Clause 104 Maintenance Requests #2

Overview

Technical, 802.3bu, Page 53, Figure 104-8

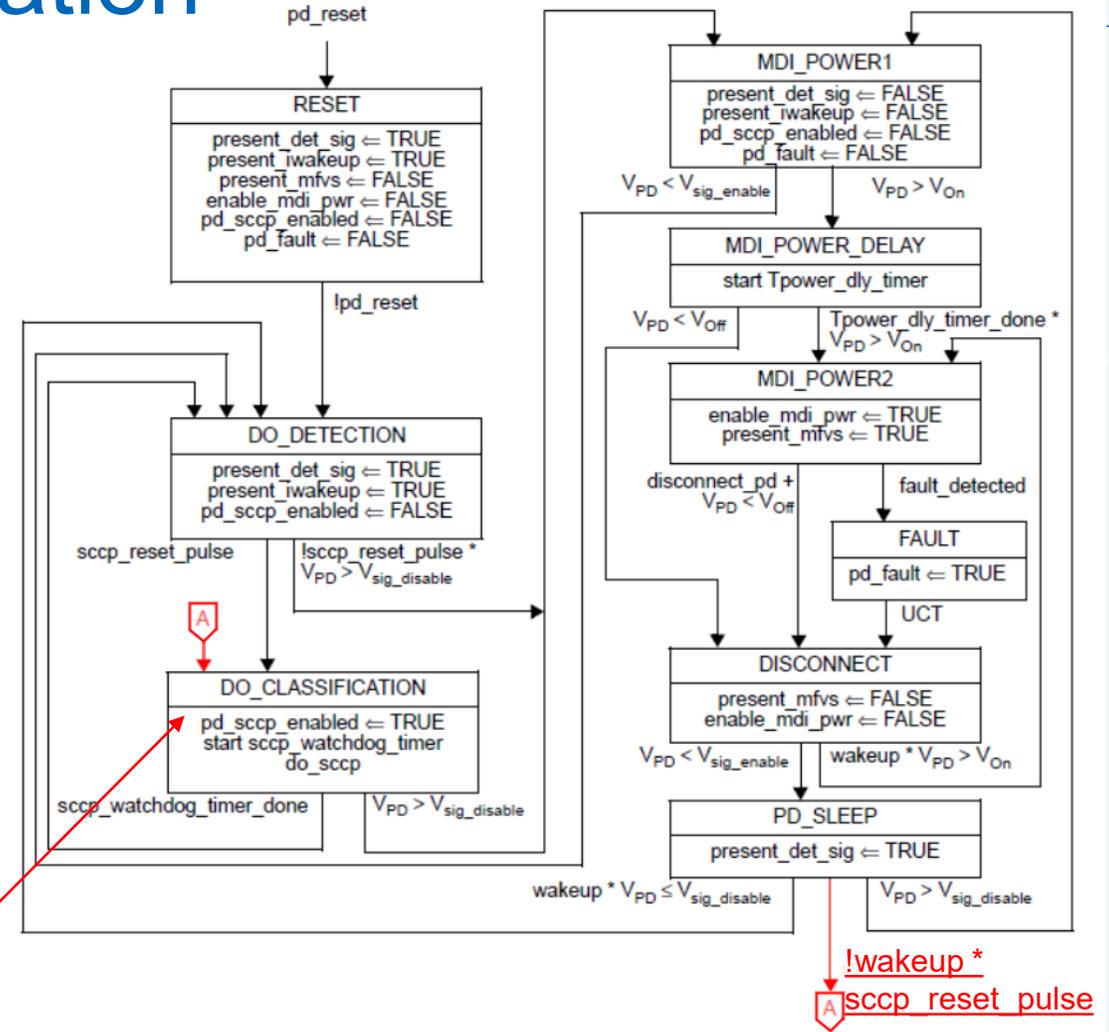
The PD state machine, as written, does not allow a PD to respond to SCCP classification on PD_SLEEP exit.

Change wakeup

To wakeup

An implementation specific variable enabling the PD to request wakeup.

TRUE: the PD requires the full operating voltage at the PI.

FALSE: the PD is ready to go to sleep or is not otherwise requesting full operating voltage.

4/27/21 proposed add:
present_iwakeup <= FALSE
